AMENDMENTS TO THE DRAWINGS

FIG.36

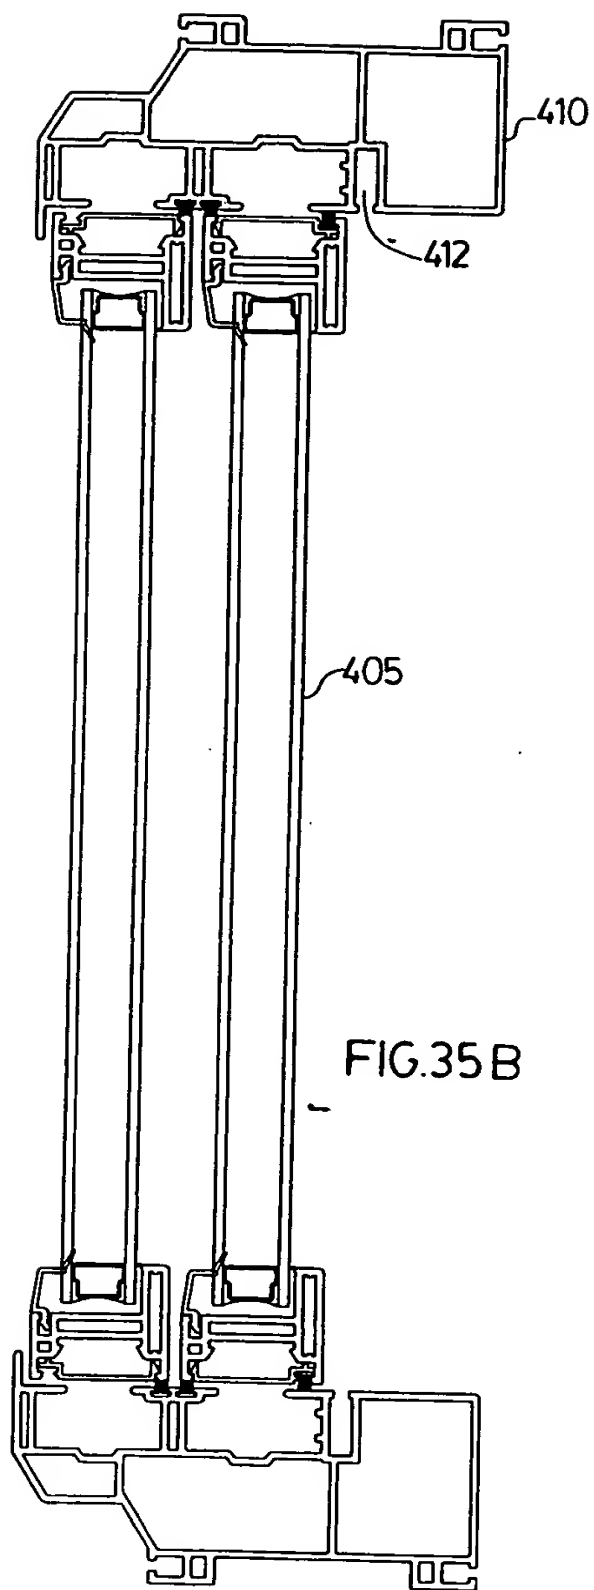
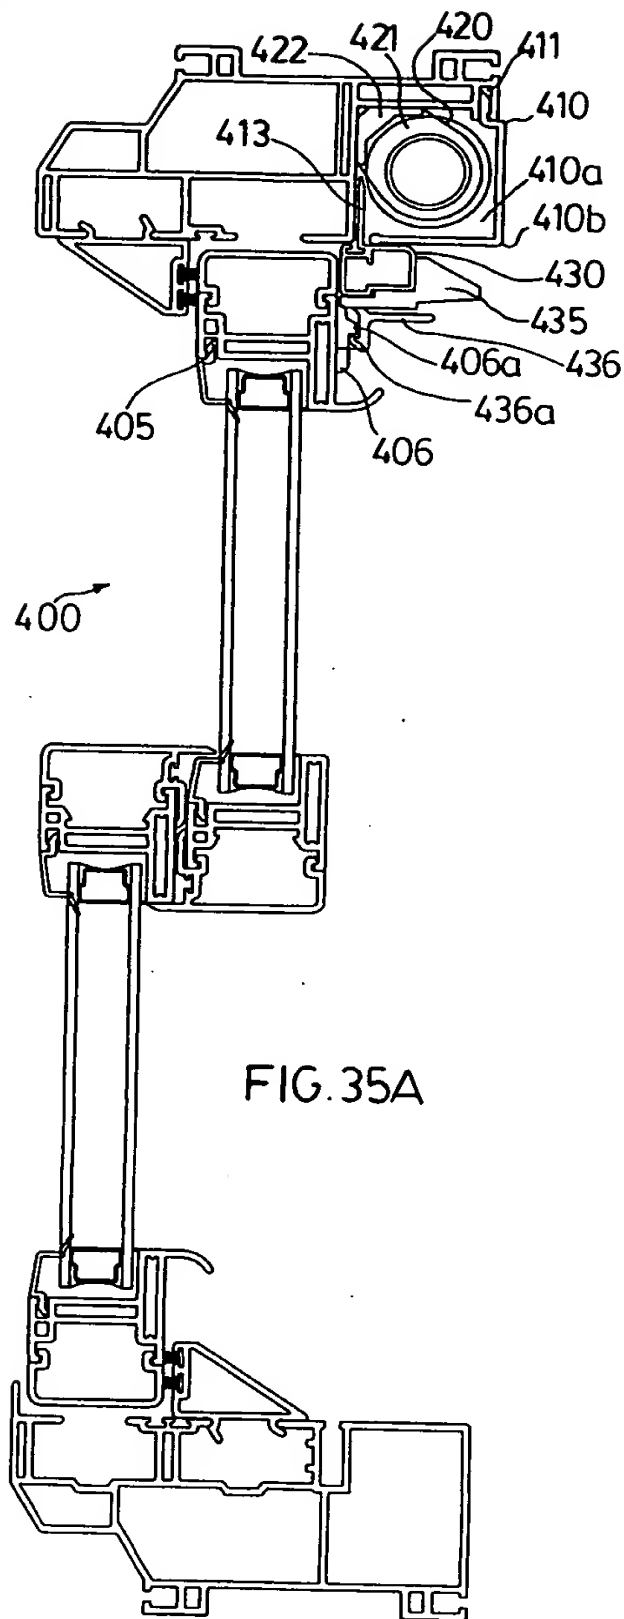
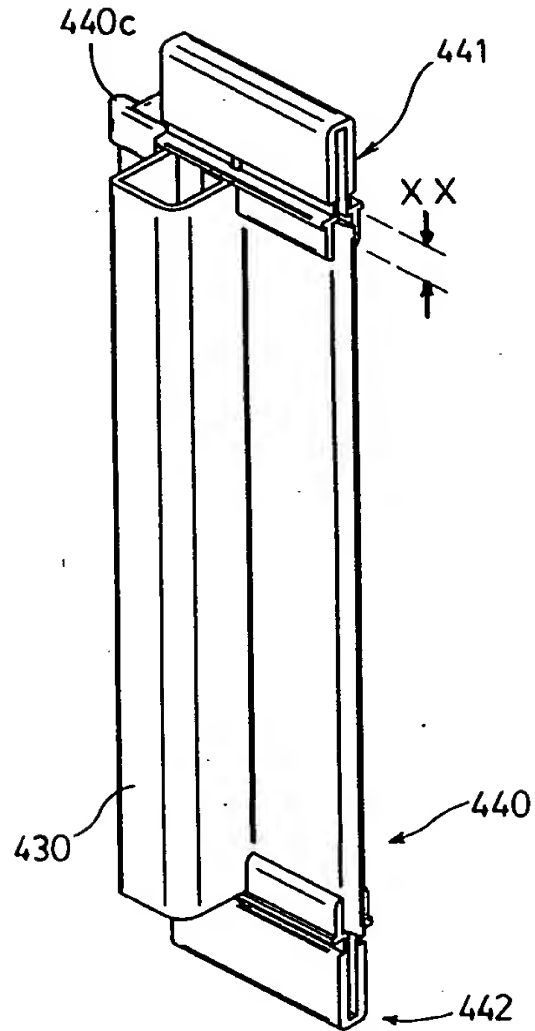
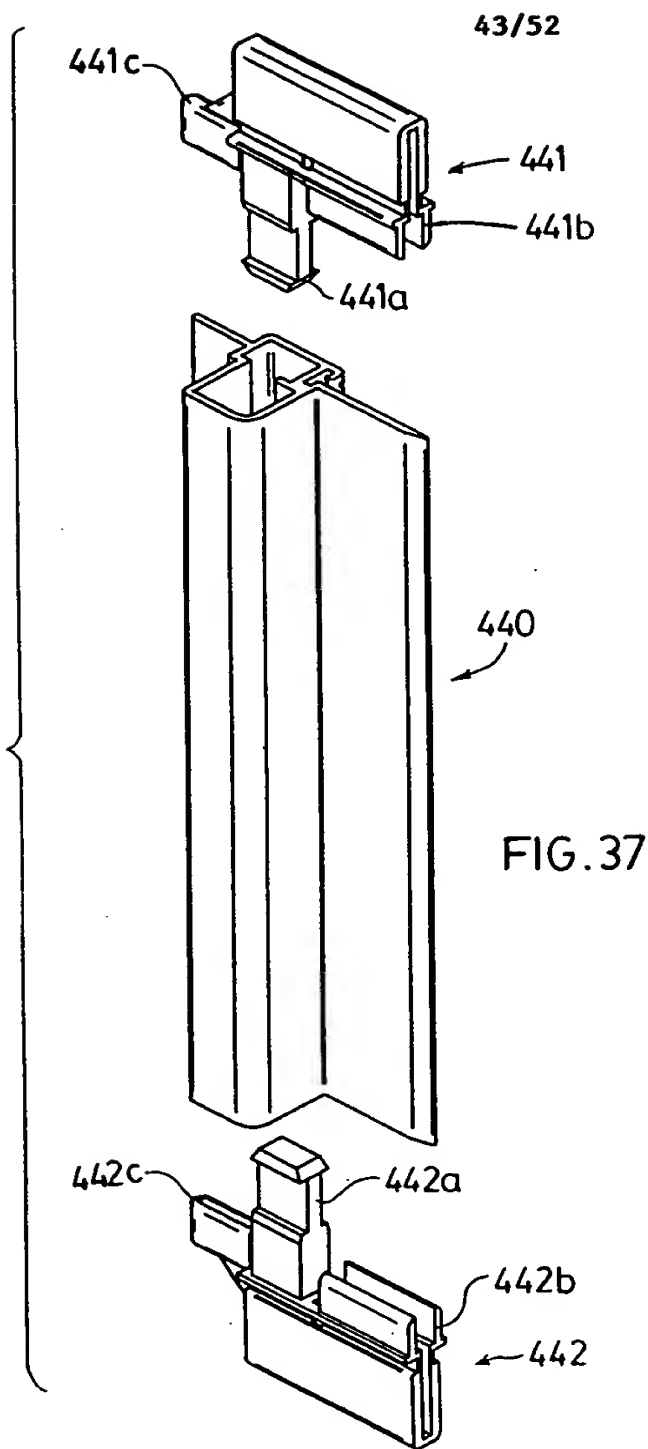
The Examiner has stated that the drawings do not illustrate the features of claims 2 and 10. Applicant respectfully disagrees. Clearly elements 441 and 442 of Figures 35A, 35B, 36 and 38 by way of example (attached) clearly indicate that the guides 412 are providing with the sill and header portions. These may be considered to be guides or grooves as defined in claim 2 and 10. The Examiner is specifically referred to page 45 of the disclosure line 6 onward wherein it states,

"Because of the design of the screen including the telescoping guides as best seen in Figure 36, the screen is guided through channel 412 as best seen in Figure 35B between fully closed and fully opened positions. The glide assembly therefore will accommodate and receive the upper edges and the bottom edges of the generally T-shaped screen portion as best seen and described in relation to Figure 20. An upper glide 441 therefore and a lower glide 442 is provided to ride within the respective channel portions 412 of the jamb framing sections."

Those skilled in the art would clearly understand this feature, for either guides 412, 442 (in claim 2) and grooves 412, 442 (in claim 10). The Examiner is referred to elements 441 and 442 which carry the extension portion of the handle, that ride in the guides 412, 442.
